# Technical Service Information

## THM 440-T4 BROKEN T.V. PLUNGER (PART NUMBERS)

Figure 1

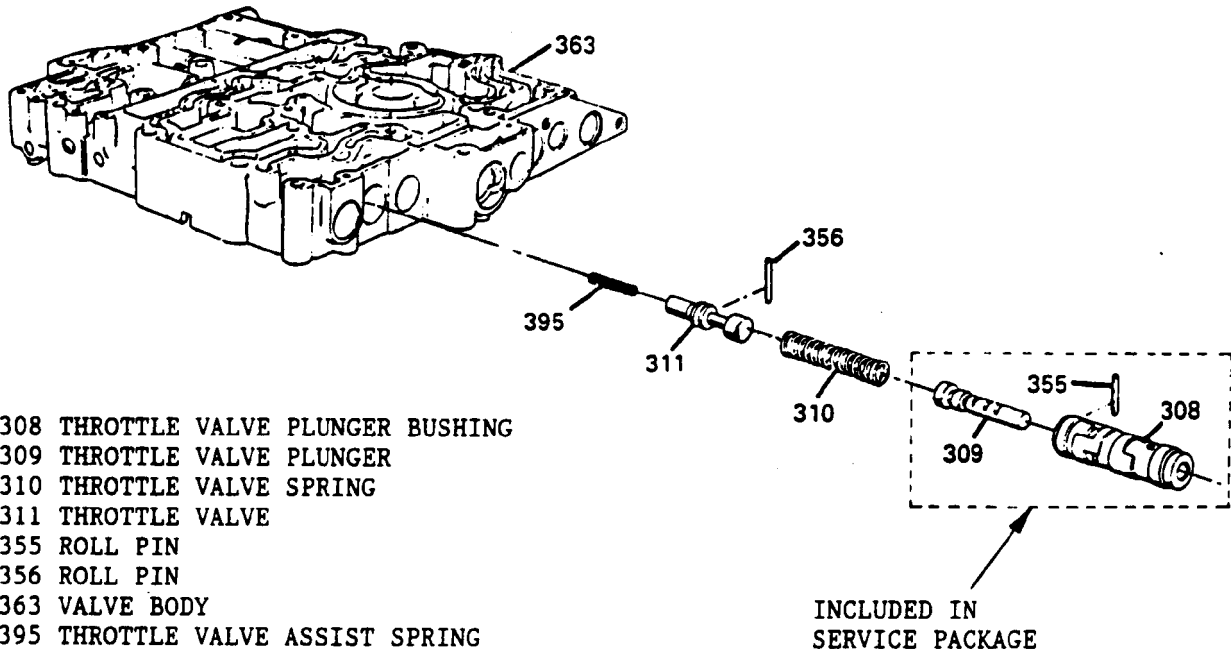
The T.V. Plunger and Bushing Assembly are now available from OEM in a service package, so that buying a valve body is no longer necessary when the TV plunger is broken or cracked (See Figure 1). Refer to the following OEM part numbers as it IS a model sensitive part.
